Coburg Principle Activity Centre Zone
Moreland Planning Scheme
Amendment C123
Transport Evidence Statement

Ms. Kate Partenio (GTA - Director)
Prepared for Moreland City Council
Instructed by Michelle Breslin,
Moreland City Council
Hearing Date: 9 July 2014
Report Date: 01/07/14

Moreland Planning Scheme, Amendment C123

Transport Evidence Statement

Figure 2.2: Coburg Initiative Bicycle and Pedestrian Network Map

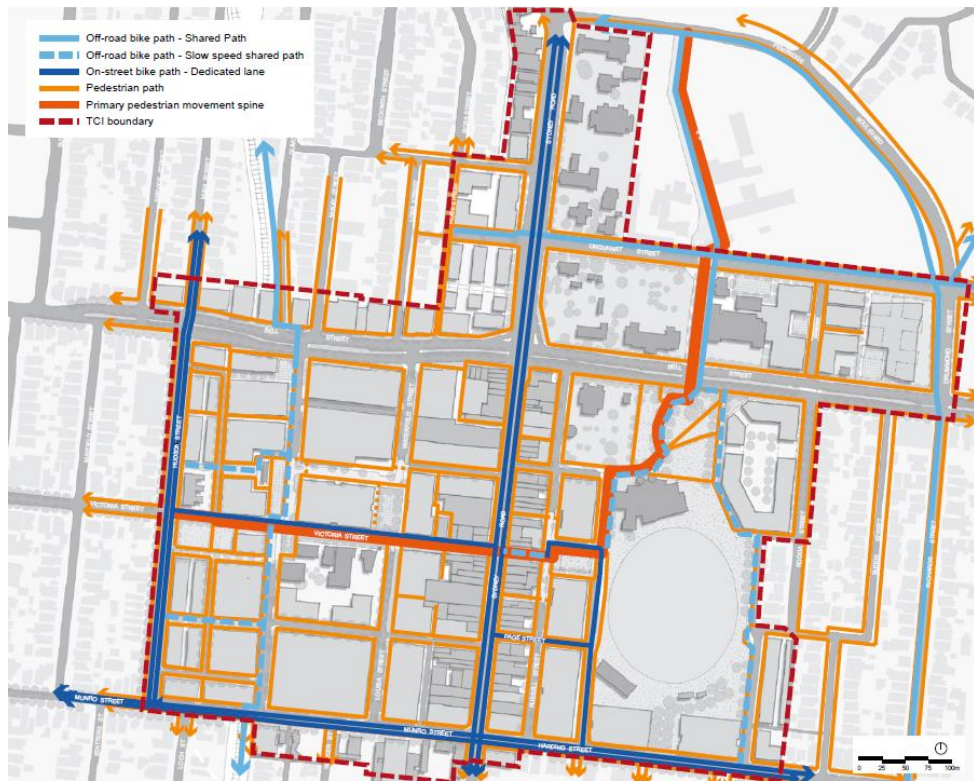
Cycling infrastructure within the separate activity centre precincts is a significant consideration in The Colours of Coburg Place Framework and Strategies (refer Bicycle and Pedestrian Network Map in Figure 2.2 below), which is proposed for Precincts 1,2,3,4 and 5 and Central Coburg 2020 Structure Plan (refer Bicycle Network Map in Figure 2.3), which is proposed to be a reference document for Precincts 6, 7 and 8. Of particular note on the difference between the Structure Plan bicycle network map and The Colours of Coburg map is the loss in the latter of the north south bike route running through the heart of the retail centre along Louisa, Waterfield and Ross Streets in The Colours of Coburg framework. This is also missing from the Precinct maps as discussed below.

In order to give action to the priority hierarchy for cyclists it is recommended that Precinct Map 1 references both the east-west and north-south bike routes through the heart of the precinct and that the Colours of Coburg Bicycle and Pedestrian Network Map be modified to include the Waterfield Street route.

That Precinct Map 1 include both an east-west (Victoria Street) and a north-south (Louisa/Waterfield/Ross Street) bike route through the heart of the precinct and that the Colours of Coburg Bicycle and Pedestrian Network Map be modified to include the north-south route.
